# MICE Hall – South Mezzanine

Jason Tarrant - STFC

- Contents
  - » Device checks with current South Mezzanine
  - » South Mezzanine change summary
  - » Conclusion

- Mezzanine & EMR

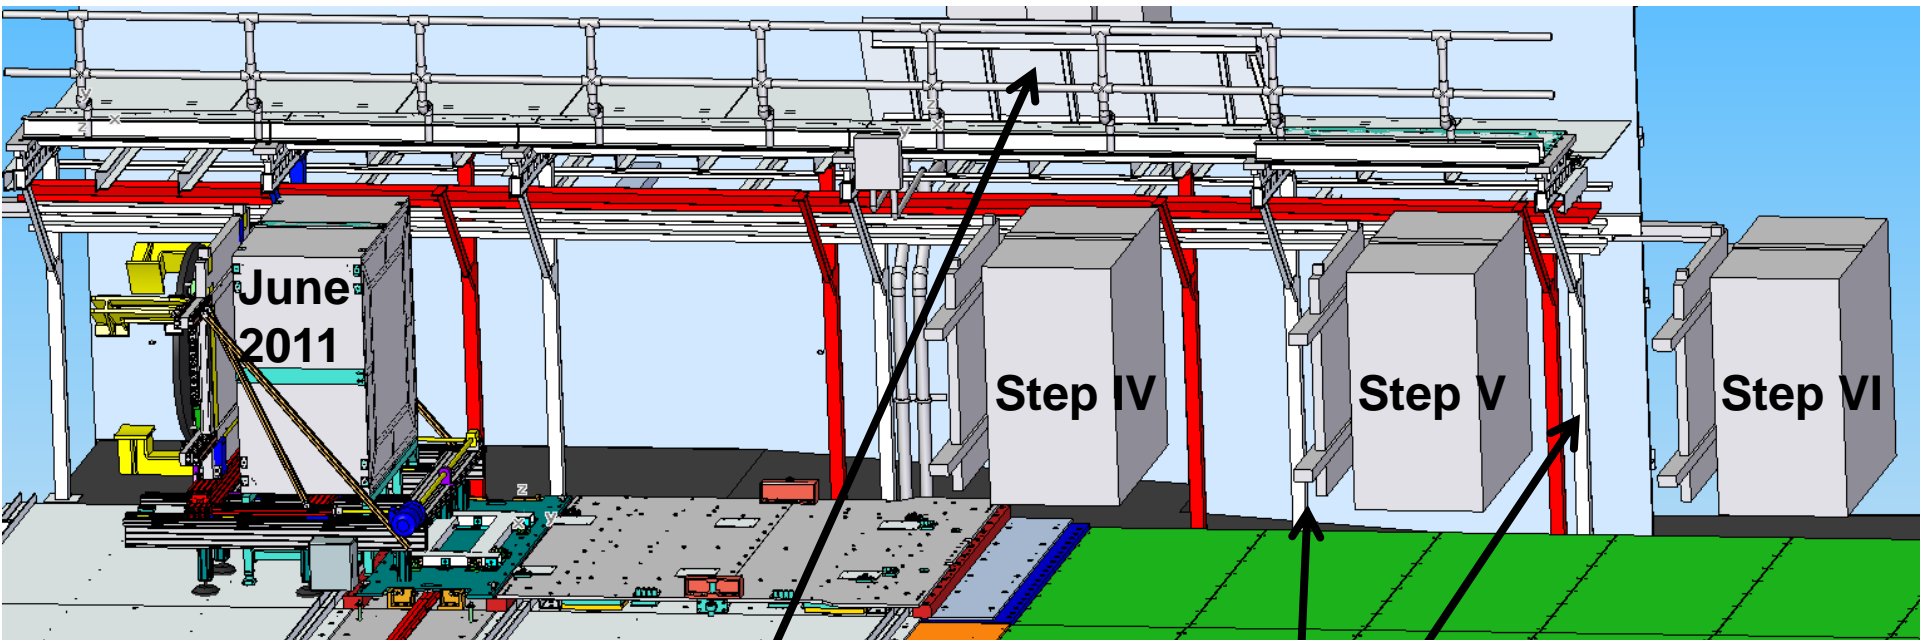
Hinged floor section  
lifted to install

Support legs  
moved (red legs  
= old position)

- Mezzanine & Hydrogen system

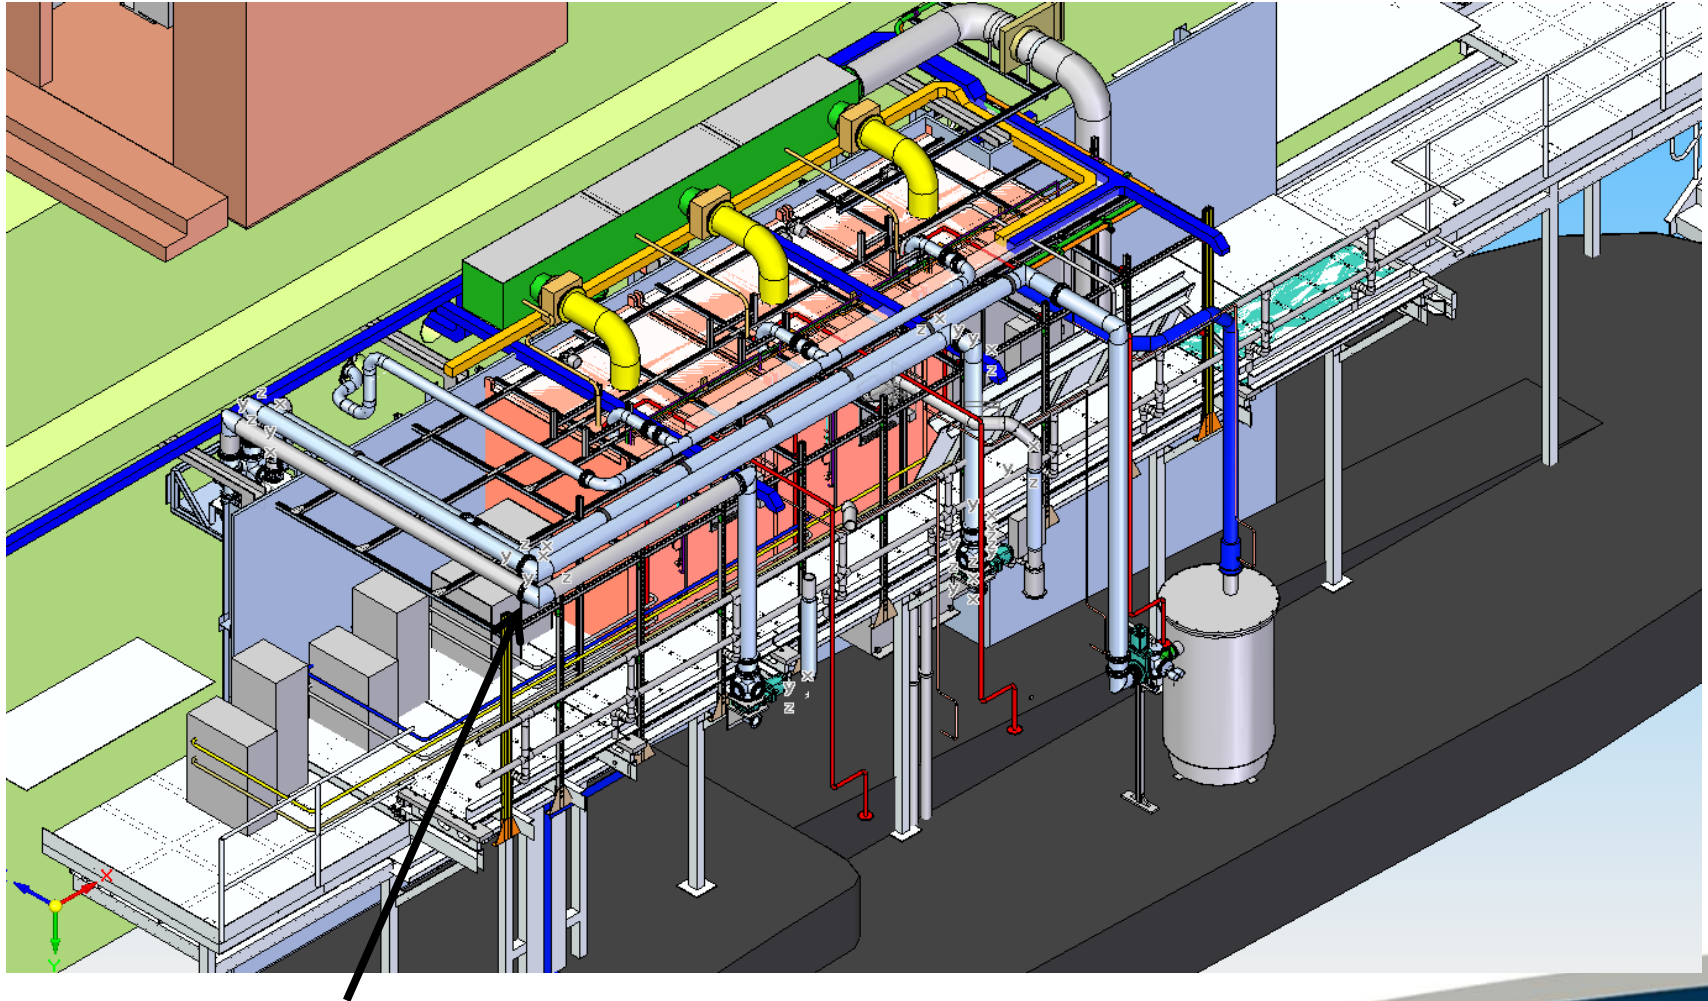
Only issue noted is that the H2 system services & frame to be raised in line with raised floor to give appropriate headroom on gangway

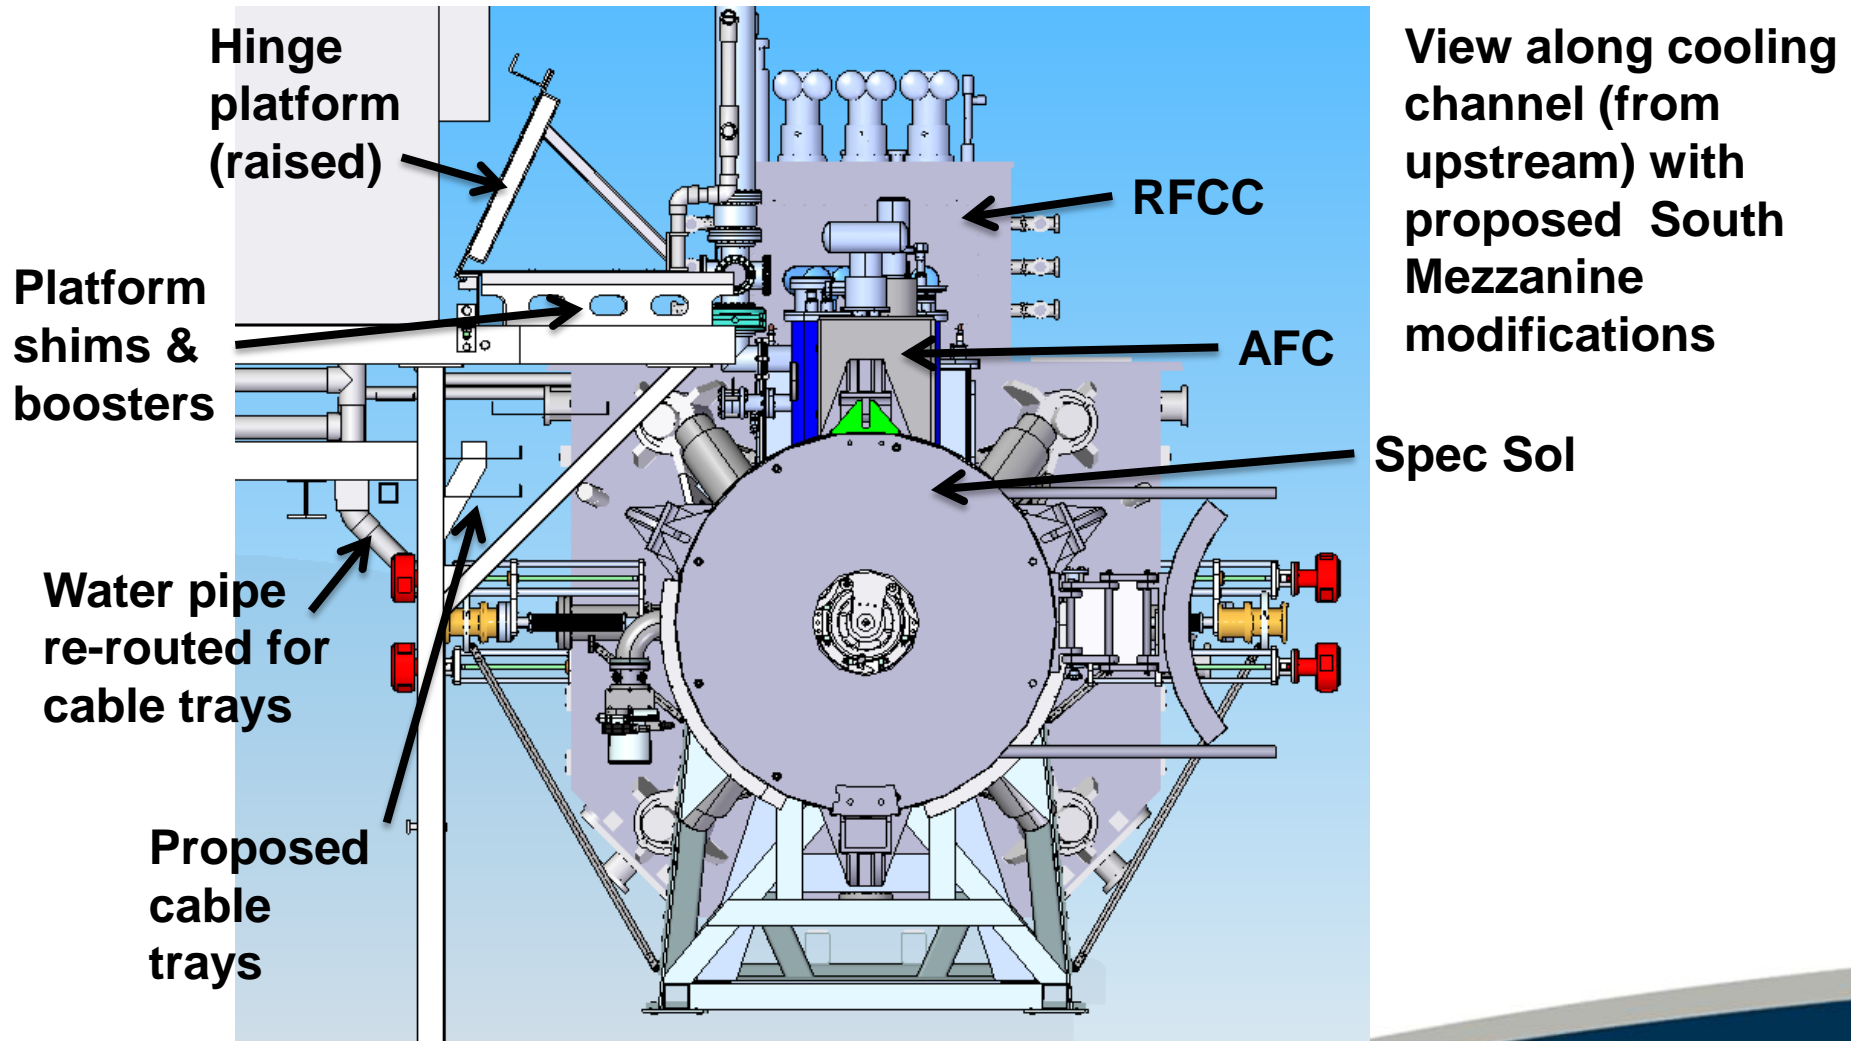
- South Mezzanine change summary
  - » Move 4 of 5 support legs to another beam, 1 extra added to minimise platform span
  - » Fit cross beam between support legs to support intermediate beams the cut back intermediates
  - » Fit hinged platform sections spanning between support leg beams
    - Higher & shorter than current mezzanine (avoids RFCC & AFC pipe line)
    - Rail with ‘dog leg’ fitted to outer beam

## » Outstanding questions

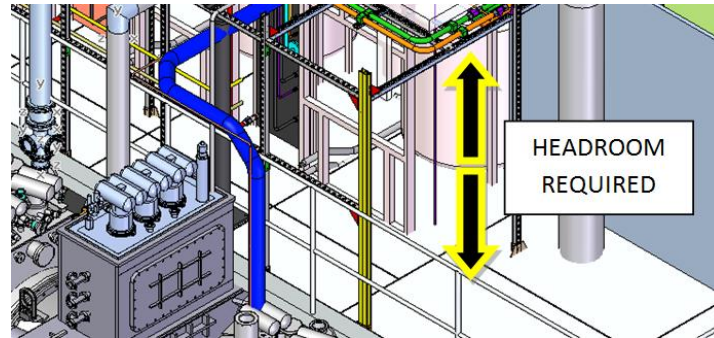
- Is the narrow walkway acceptable for safety?
  - OK'd by RAL safety, but suggested leave as late as possible to allow H2 system to be installed in relative comfort, i.e. Widest gangway
- Structurally OK?
  - Spoke with structural engineering consultant = OK'd in principle but awaiting final design / manufacturing drawings

### – Spectrometer Solenoid shutter mechanism

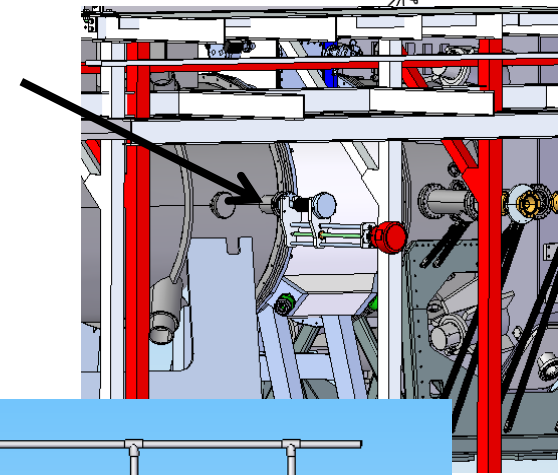
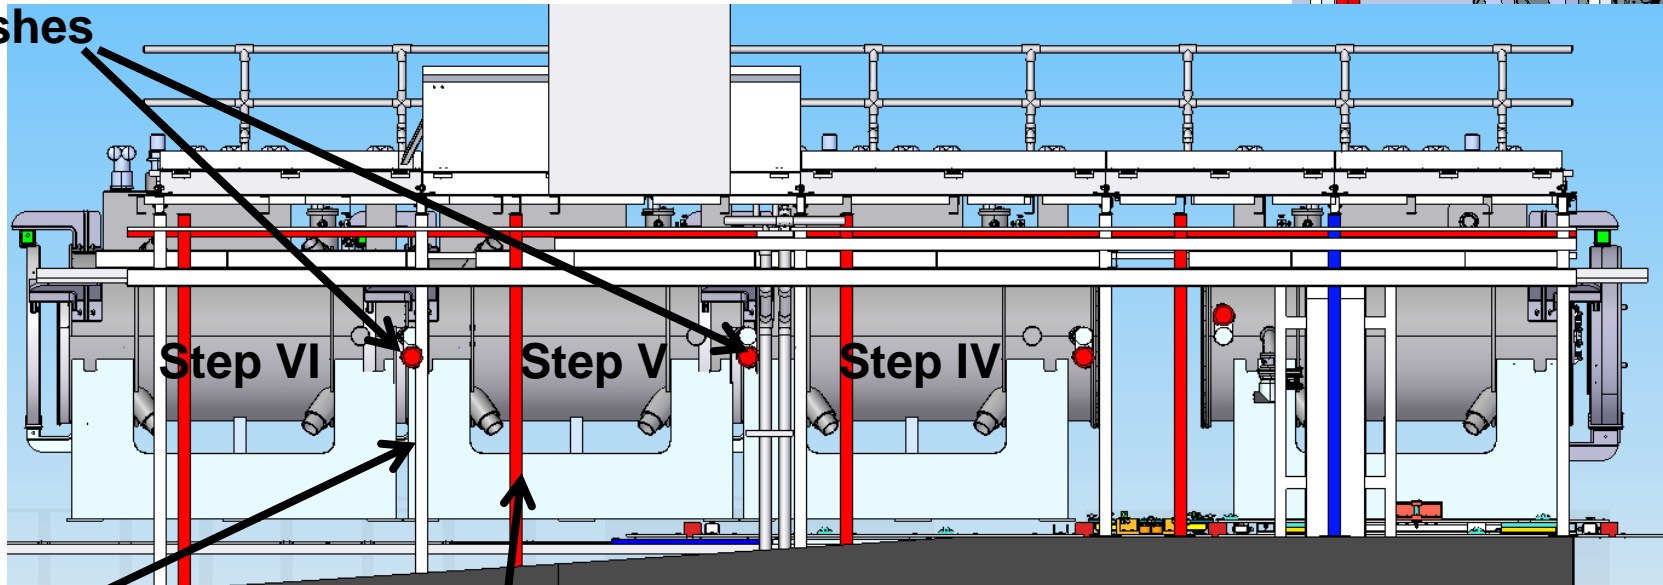
- Shutter mechanism being redesigned?
- Could mechanism be modified?

To move post again would make platform span too big

Red post is old position = big clash with AFC

### – AFC Valve

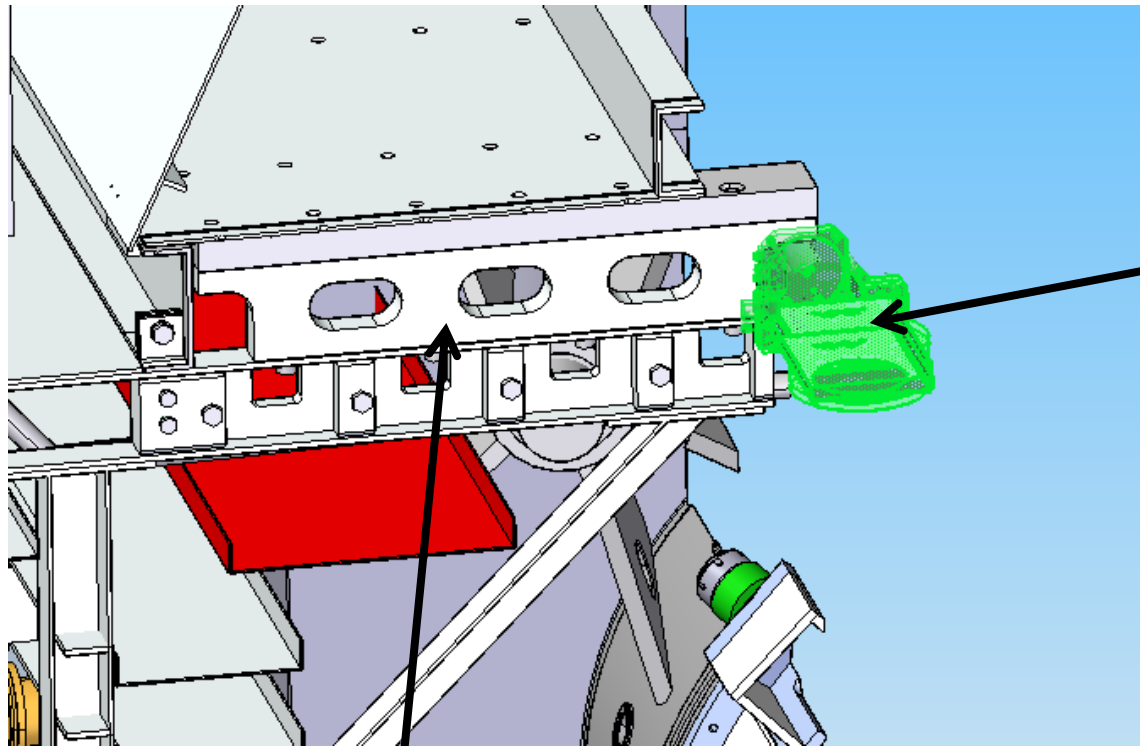
- Final placement will determine extent of cut to beam & platform shims / boosters

Valve on middle AFC

Platform shims &  
boosters
